Planning Commission Vote Report

Subject: Change of Zoning Vote Report

Petition: P.Z. 04-2009 Spirit Energy, LLC (13506 Olive Blvd.)

PRELIMINARY DEVELOPMENT PLAN

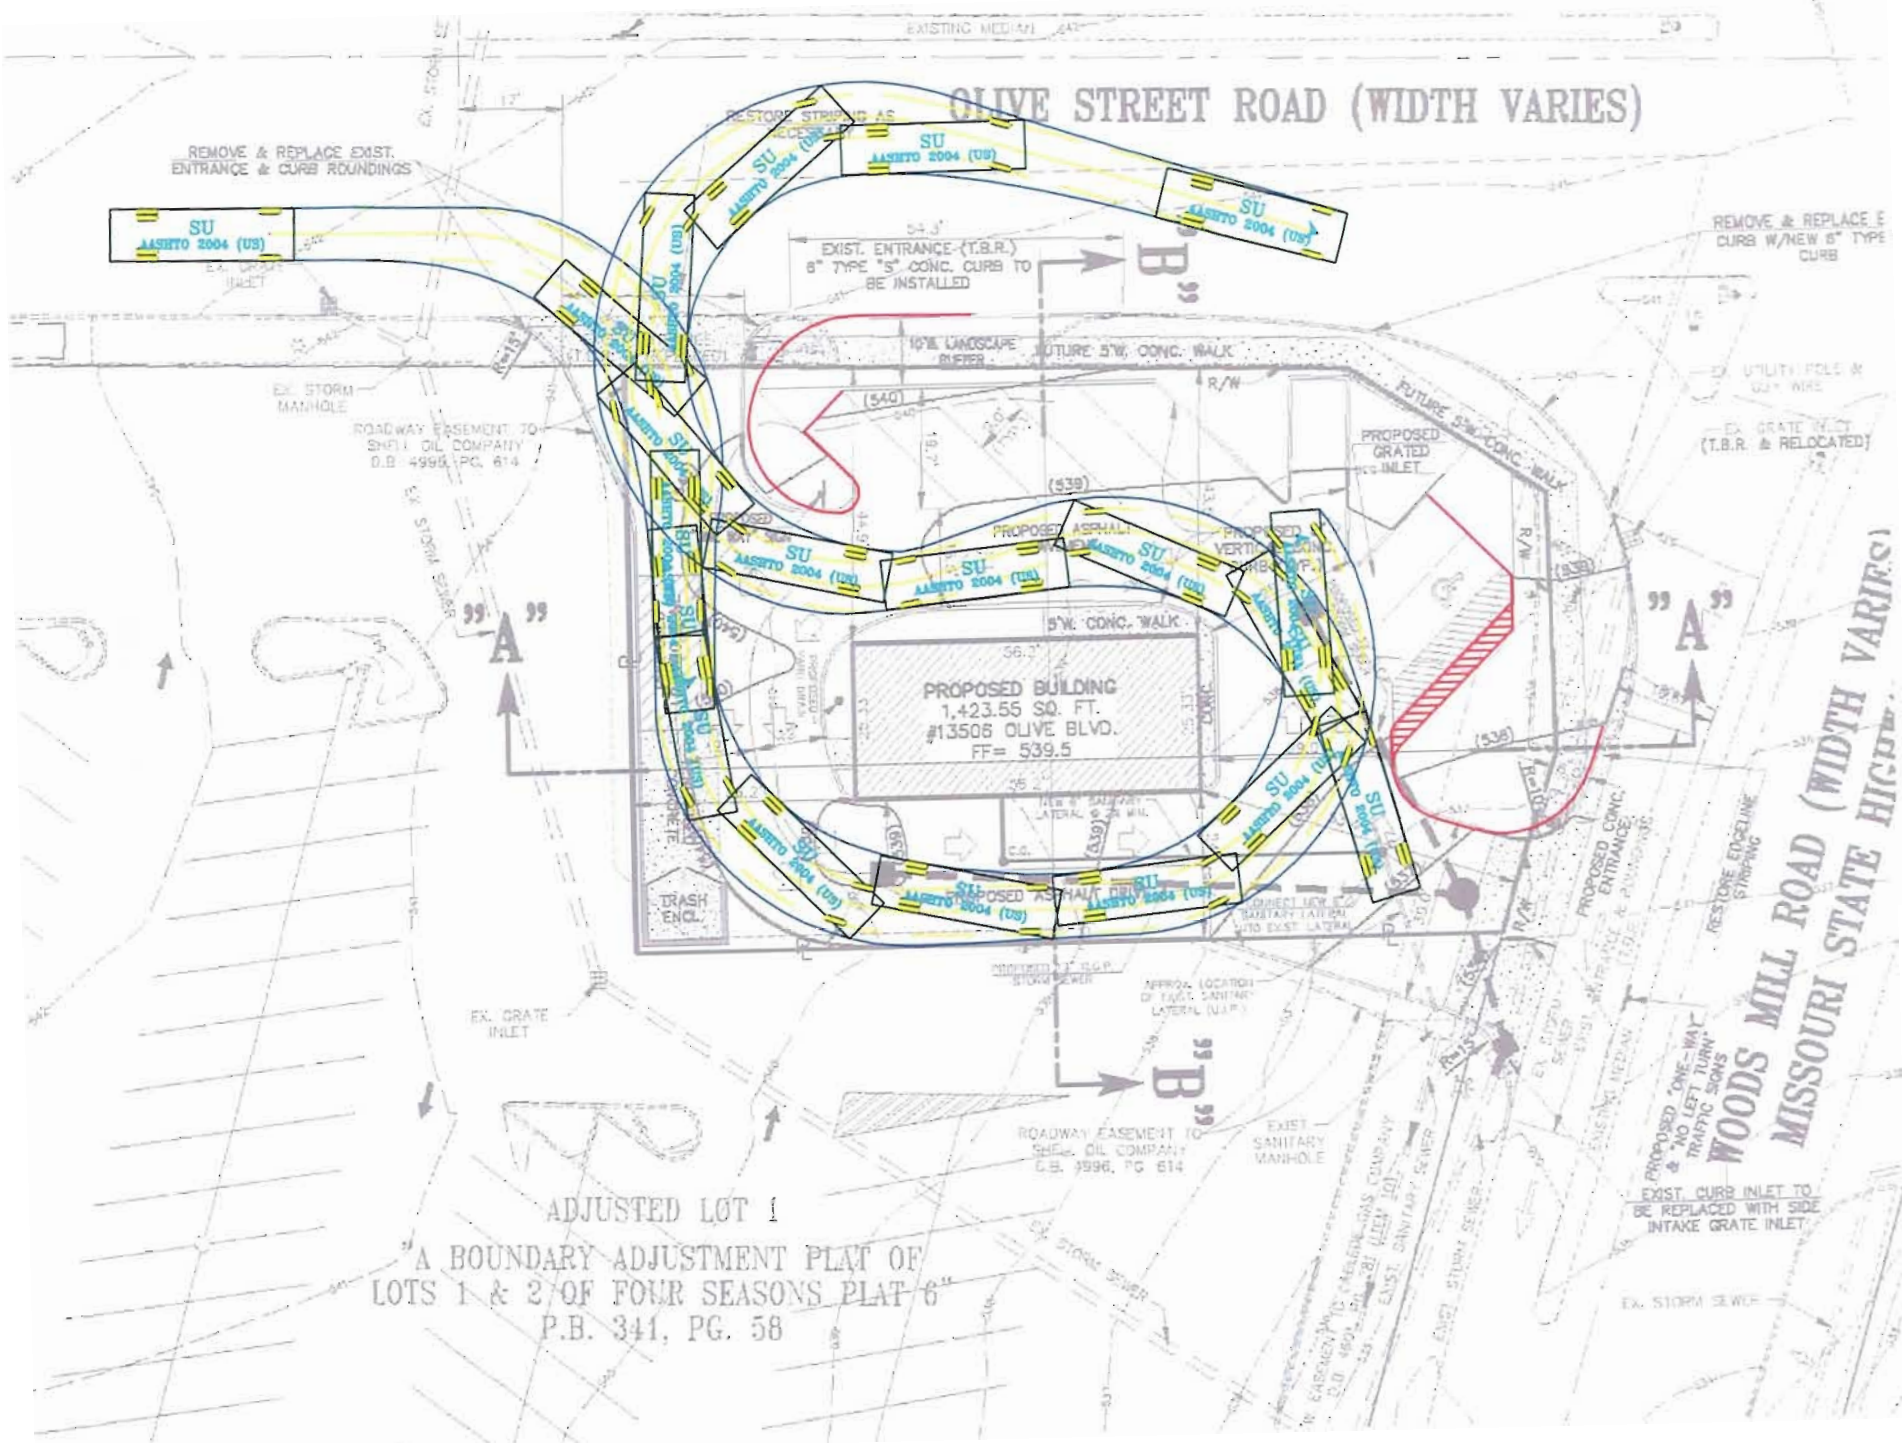
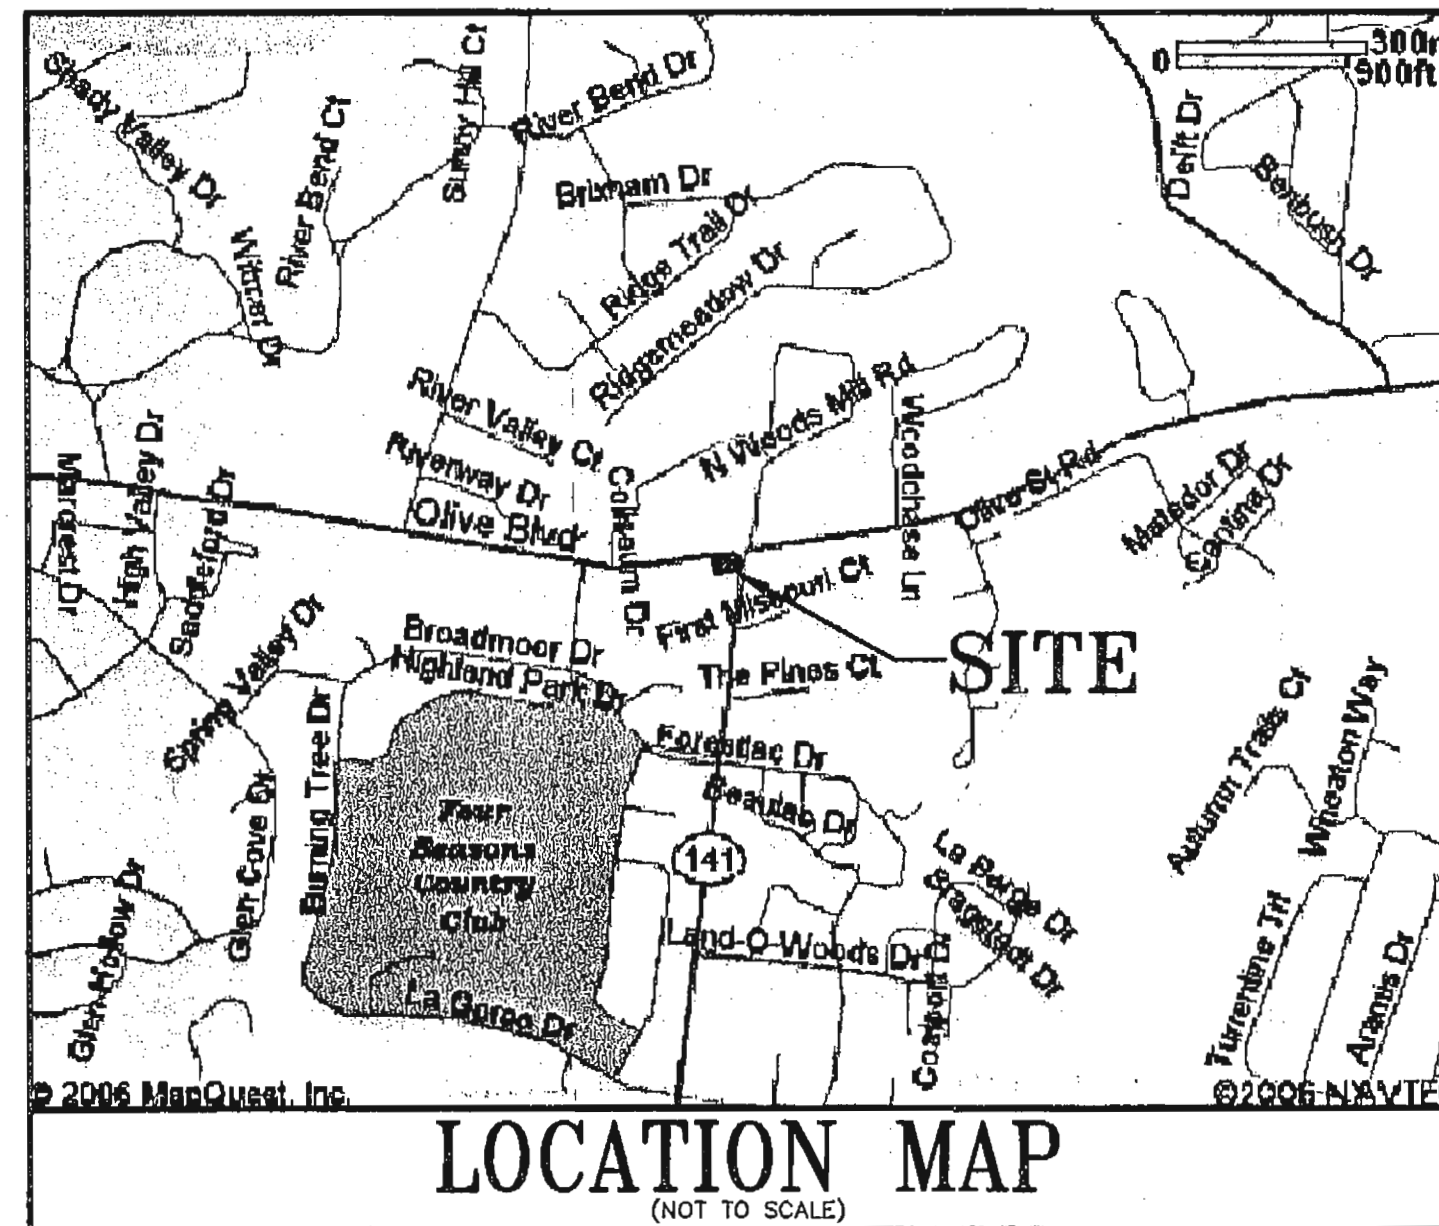
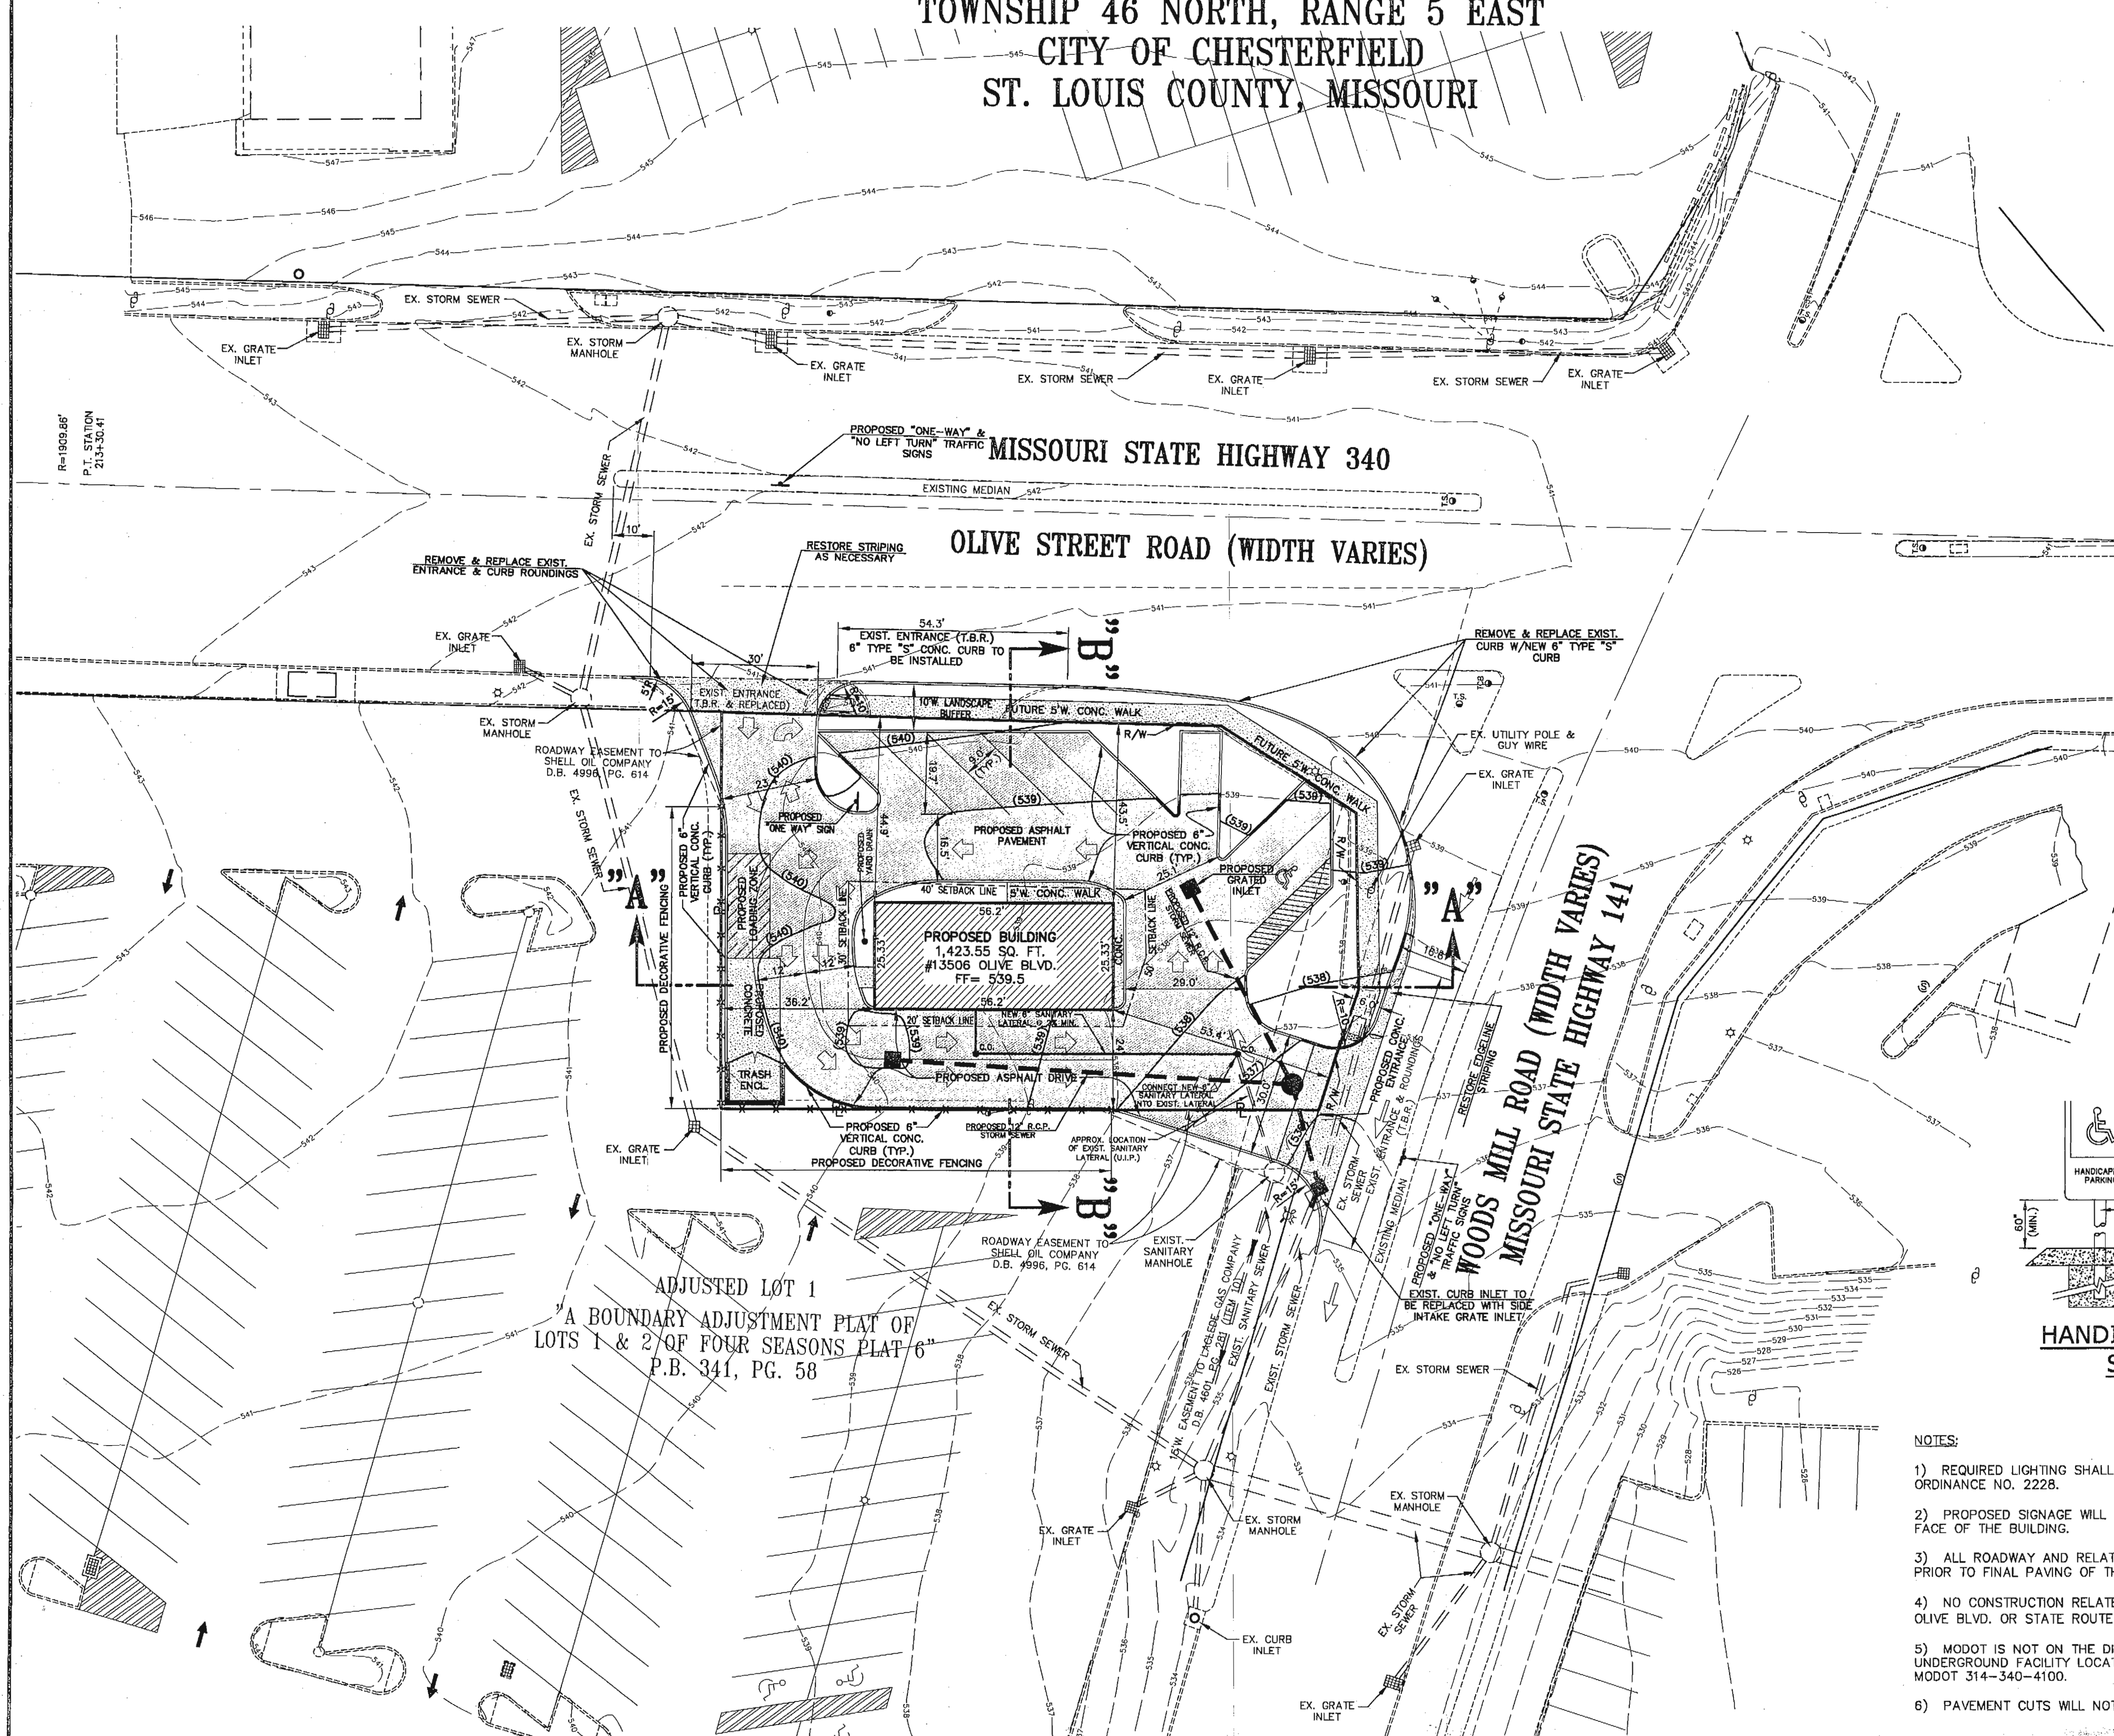
The preliminary plan submitted for the public hearing did not conform to the original comments submitted by MoDOT with respect to access to and from Woods Mill Road. Since that time, MoDOT has submitted revised comments to allow the proposed right in, right out access along Woods Mill Road based on the findings of the update to the traffic study.

1. Provide revised comments from the Missouri Department of Transportation or remove the entrance from Woods Mill Road.

2. Provide an update to the traffic study prepared for the site dated December 06, 2006 that specifically addresses the following:
 - a. Effect of the relocation and extension of Highway 141 on the proposed development and traffic;
 - b. On-site circulation, including:
 - i. Whether the current proposal provides adequate stacking area for the drive-thru window and a proposed order board,
 - ii. Impact of motorists waiting to exit the site as it relates to on-site circulation,
 - iii. Ability of the site to safely accommodate a drive-thru service, as currently proposed, and
 - iv. Ability of a single unit truck to safely maneuver around the site.

3. Provide a curb and fence around the perimeter of the site to clearly delineate the cross access is currently not provided

Response: Petitioner is working with Missouri Department of Transportation to resolve this issue and will continue to work with MO DOT to achieve resolution prior to completion of the proposed rezoning.

Response: Enclosed is a letter from Petitioner's traffic engineer, Crawford, Bunte, Brammeier which provides information regarding the decrease in traffic at the site projected as a result of the Highway 141 relocation/ extension. Such decrease will only improve issues related to the Olive & 141 intersection and traffic flow at this proposed location. For the remainder of the rezoning process and during the site plan approval phase, Petitioner, in conjunction with City staff and Petitioner's engineers and consultants, will continue to explore additional ideas which could improve circulation and access for the site.

Response: Petitioner acknowledges with and will comply with this requirement.
